Mt. Hope High School
Bristol, RI
Pare Project No. 23099.01

February 11, 2025
Page 1 of 8

**RESPONSES TO BETA PRELIMINARY PLAN PEER REVIEW COMMENTS DATED
JANUARY 24, 2025**

EXISTING CONDITIONS
DATE ISSUED: 3/5/93

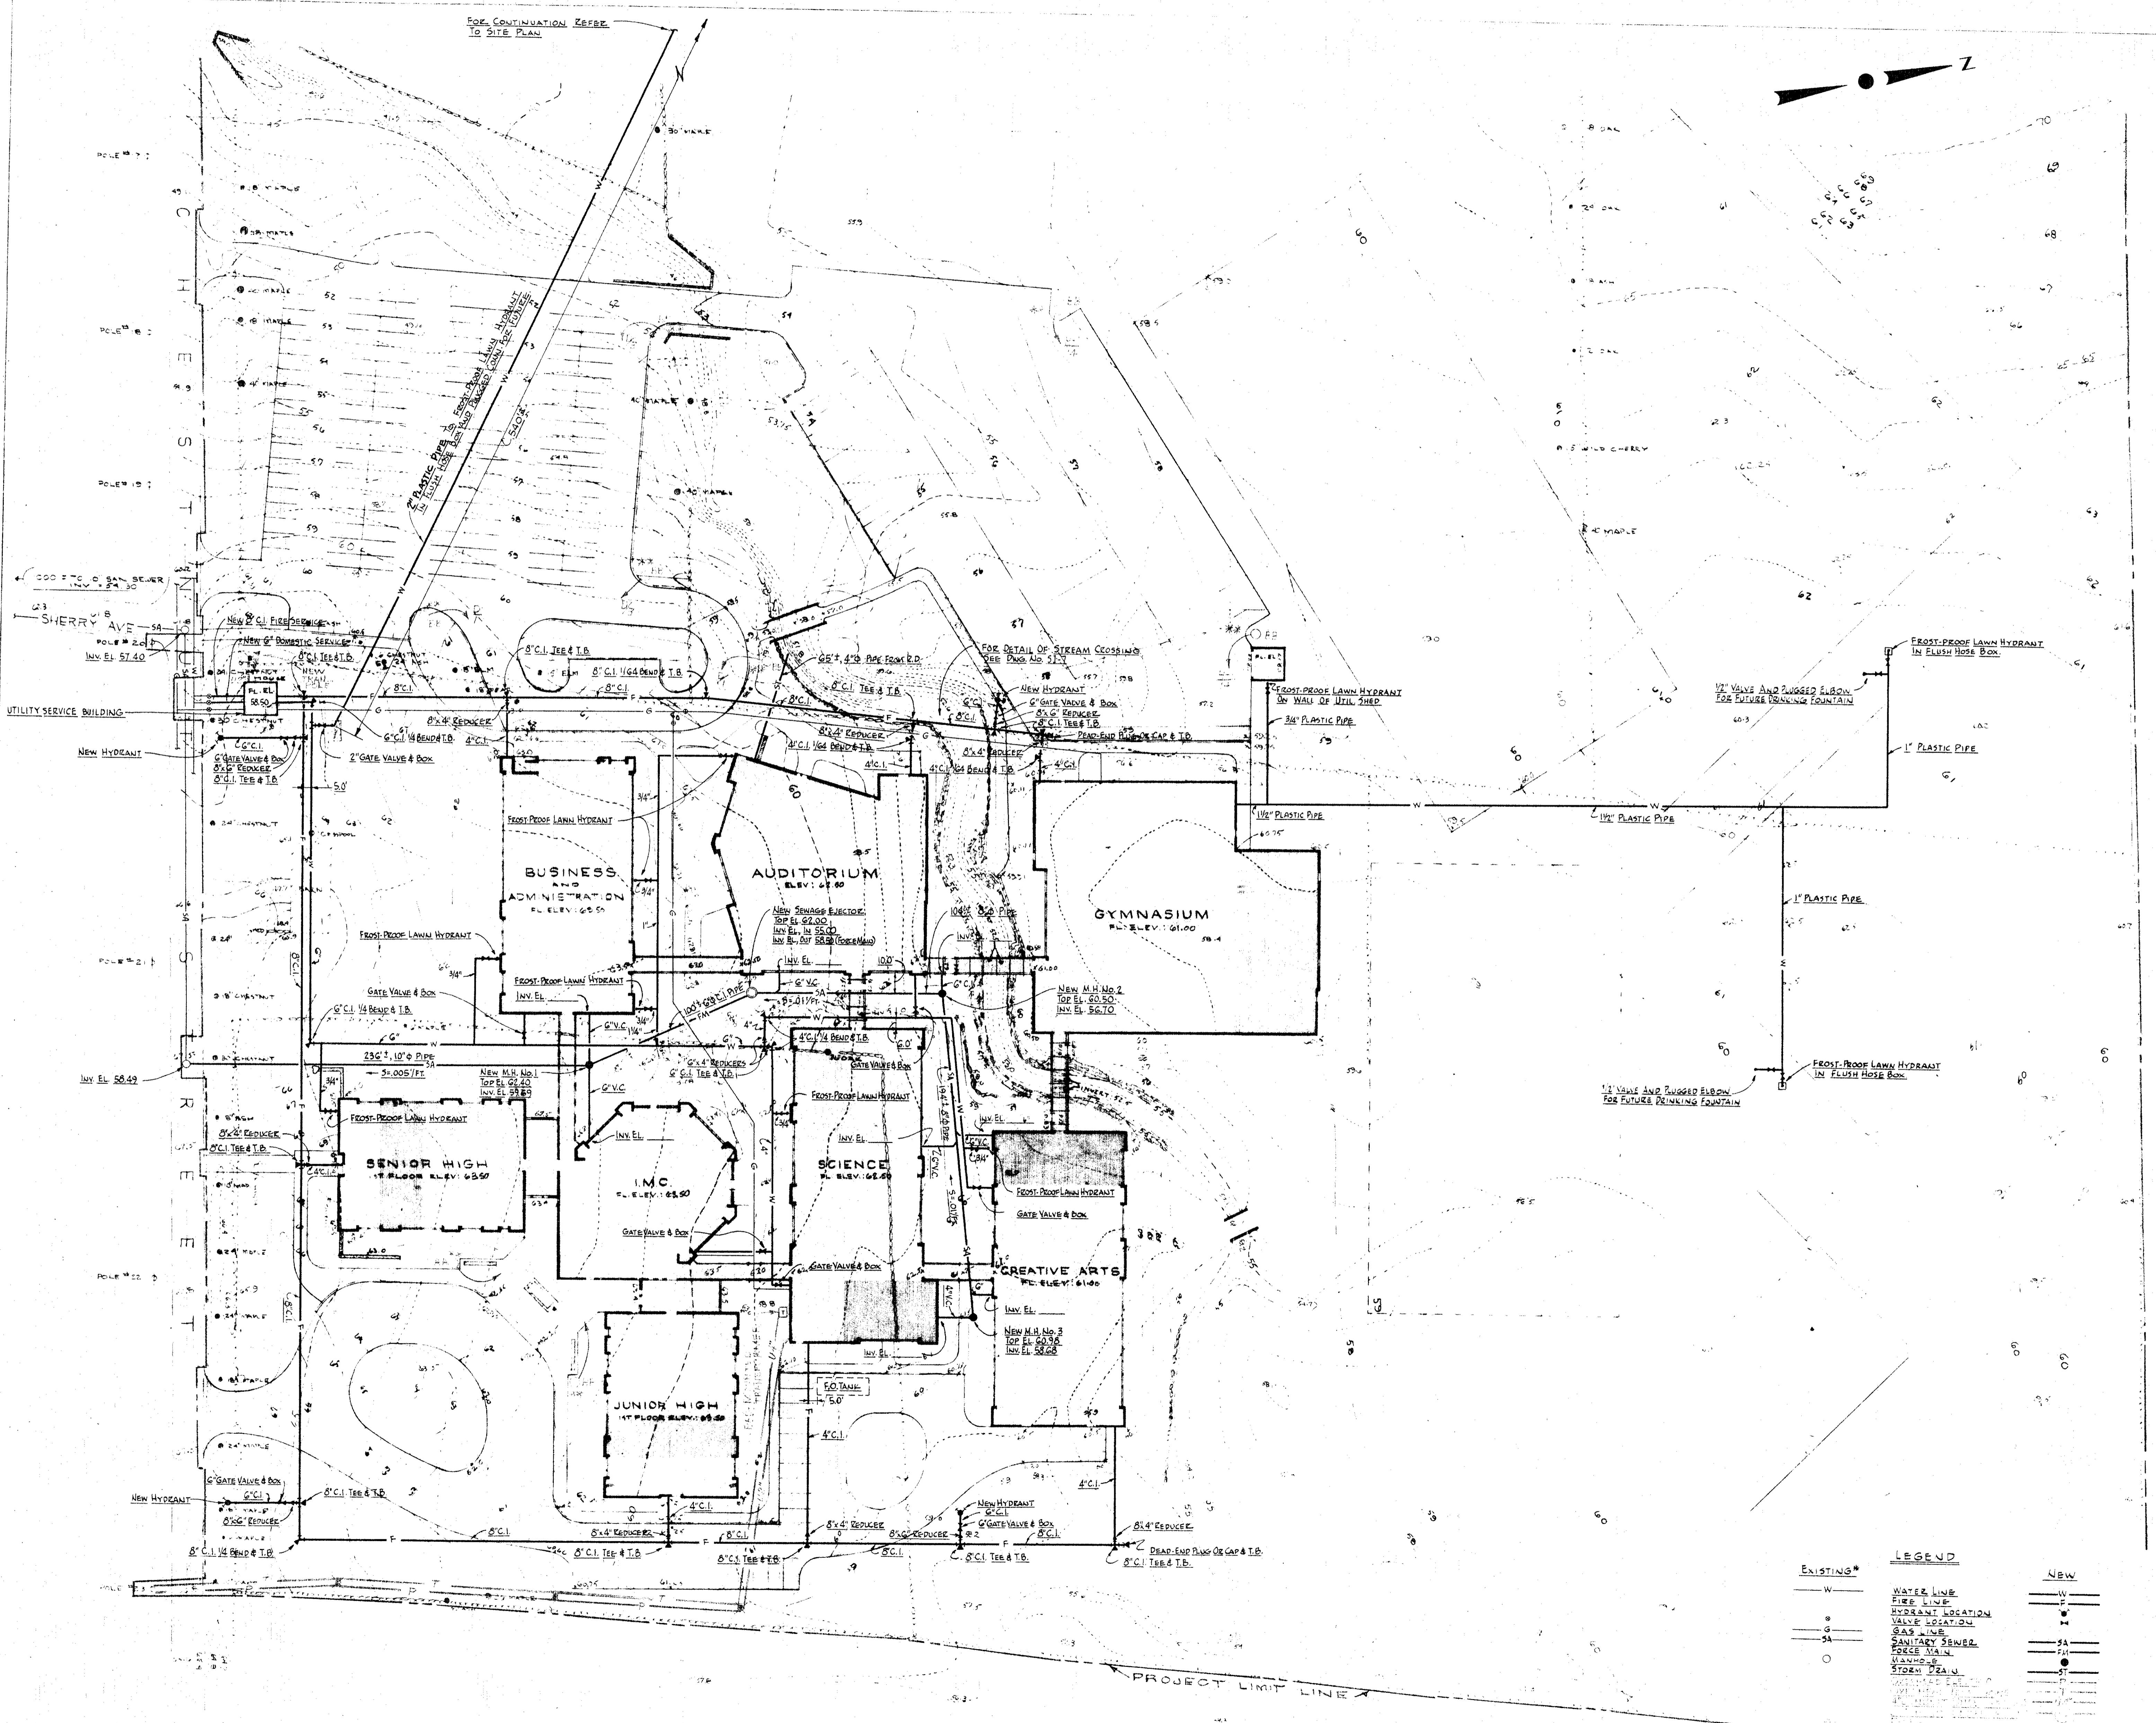
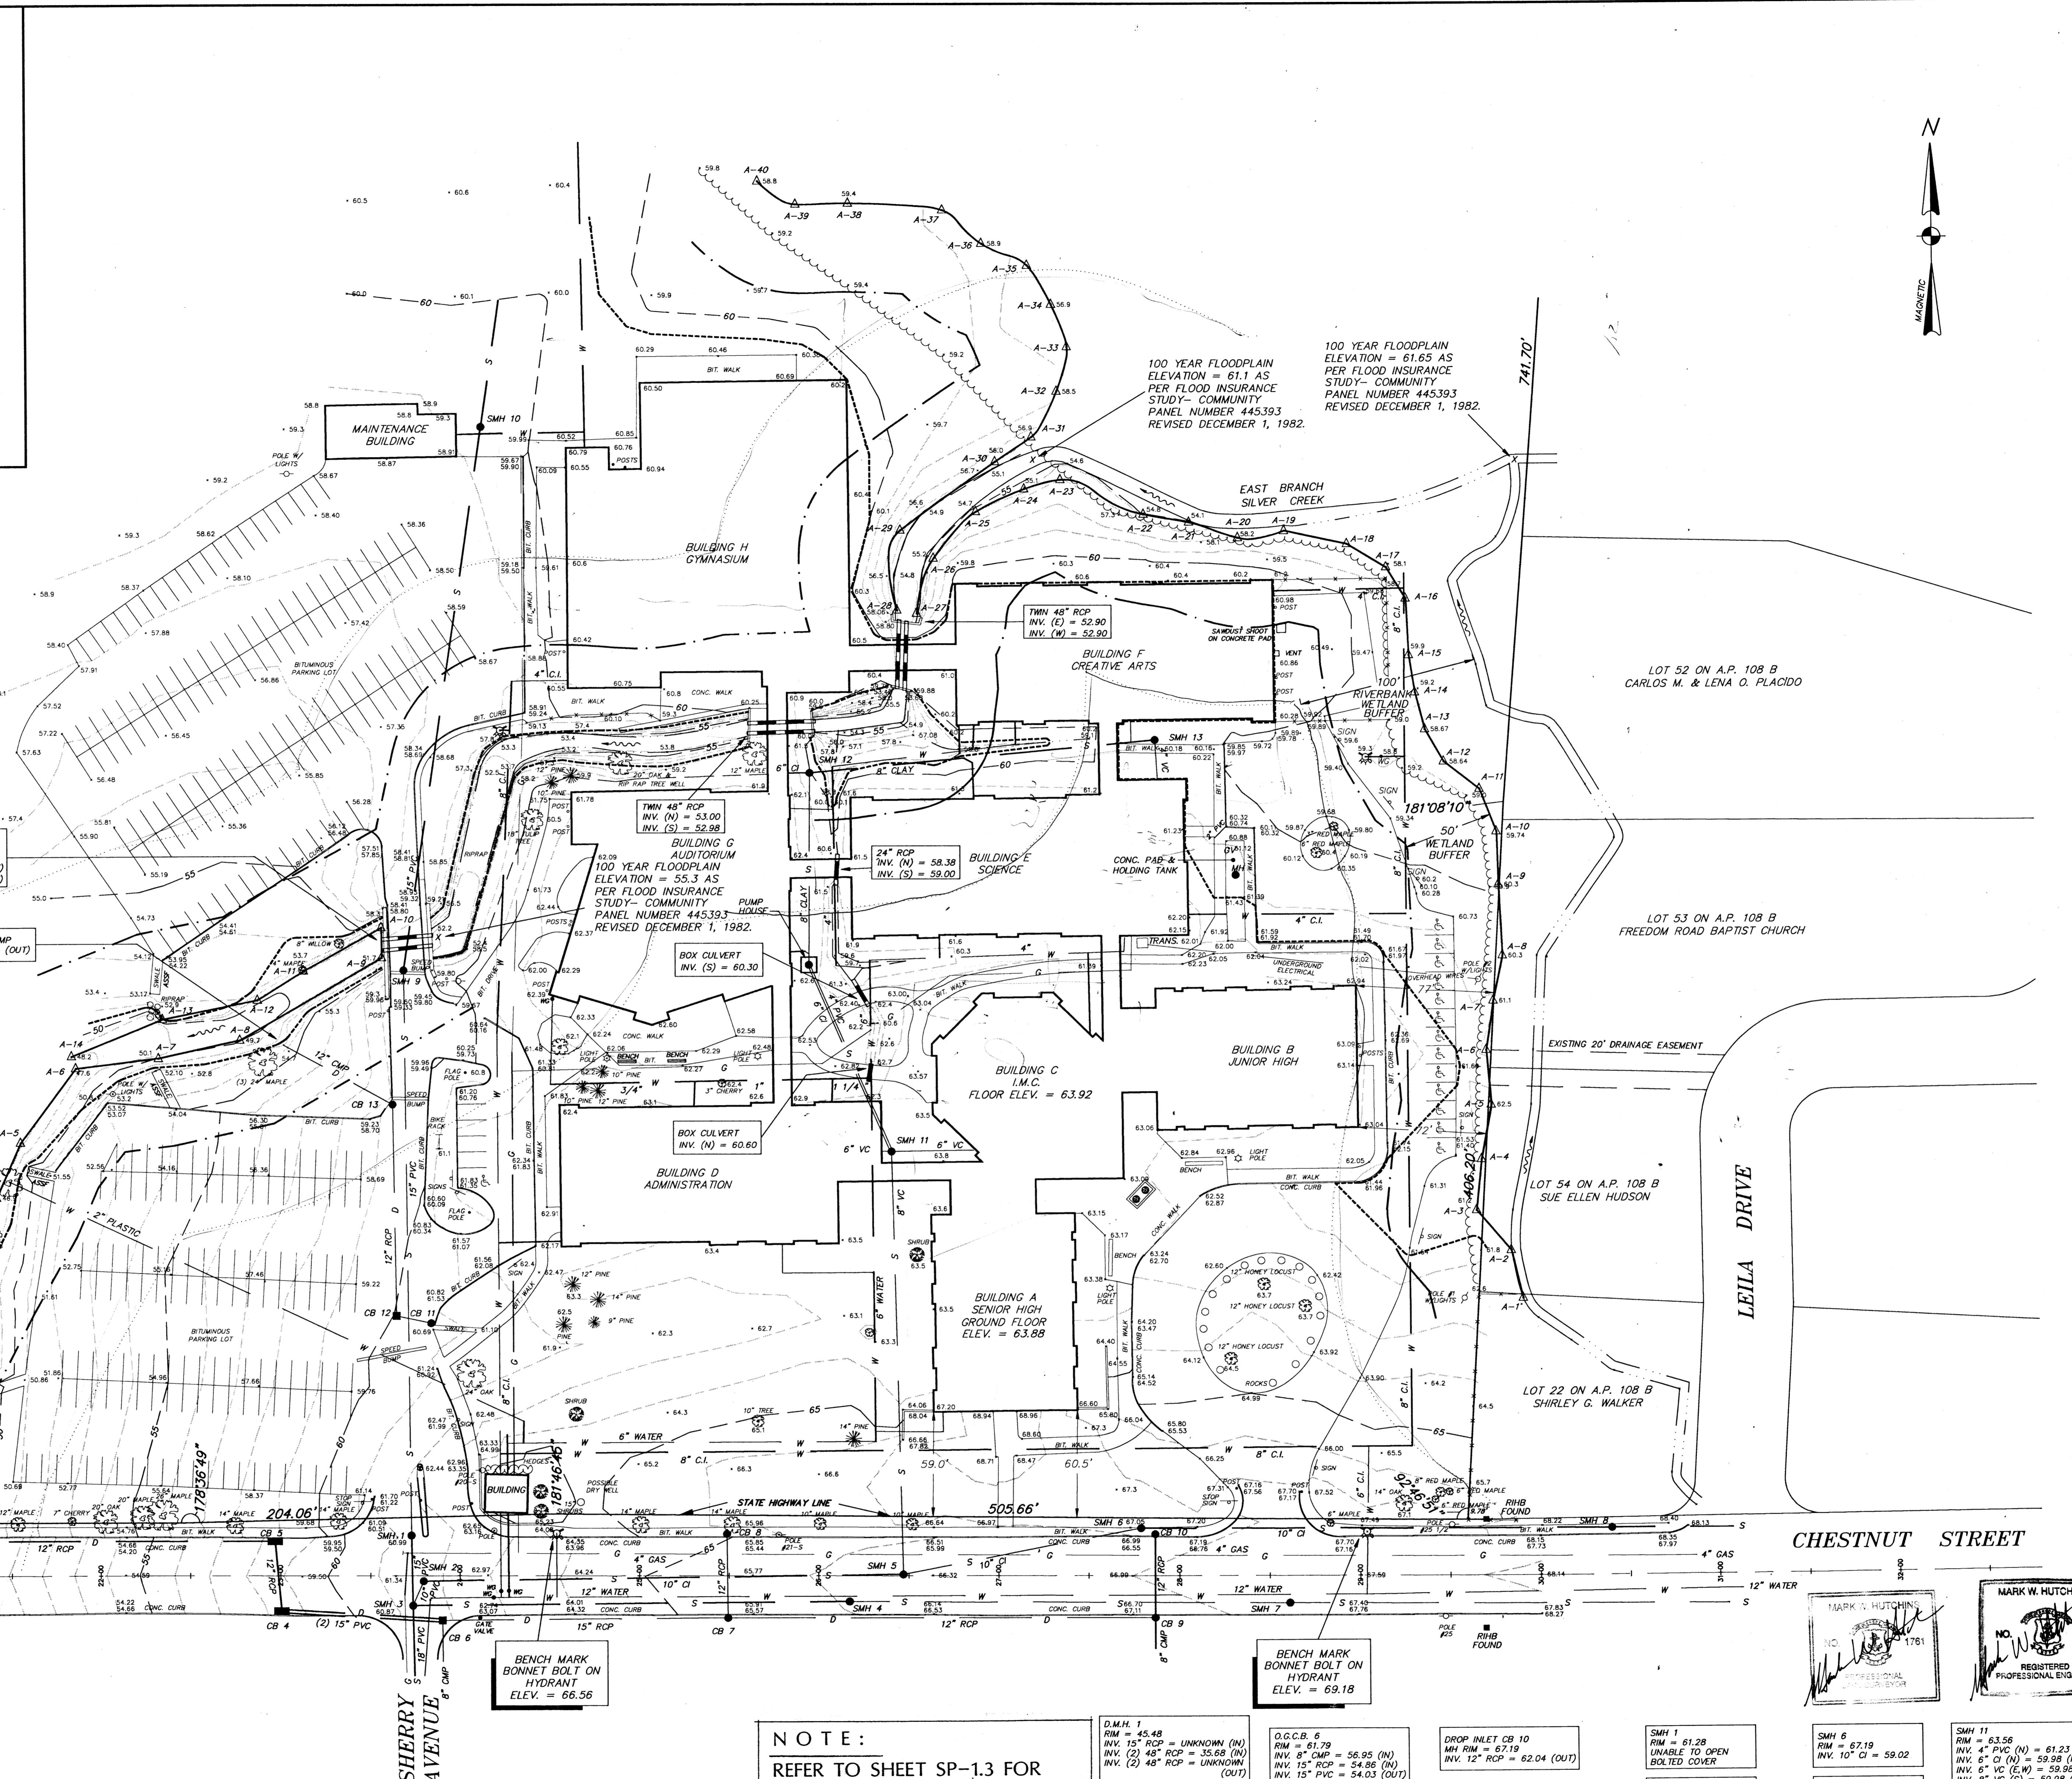
- **COMMENT:** Original school was built in 1965. What is the age and condition of the current culverts? Are they structurally sound? Have they been inspected by a structural engineer? Has the design team considered replacing these culverts as part of the project?

- **COMMENT:** Please verify that survey is correct. It shows the culverts each having a negative slope. The first set of culverts are depicted as 40-inch on the upstream side and then 48-inch on the downstream side.

RESPONSE: Culverts are depicted on the enclosed Mt. Hope High School record plans dated 1964 and 1993. The project's structural engineer has not reviewed the culverts. Replacement of the culverts is anticipated to require a Significant Alteration Permit from RIDEM and require enhanced study of Silver Creek.

The surveyor confirmed existing pipes are 48" diameter. Surveyor will provide updated existing conditions plan.
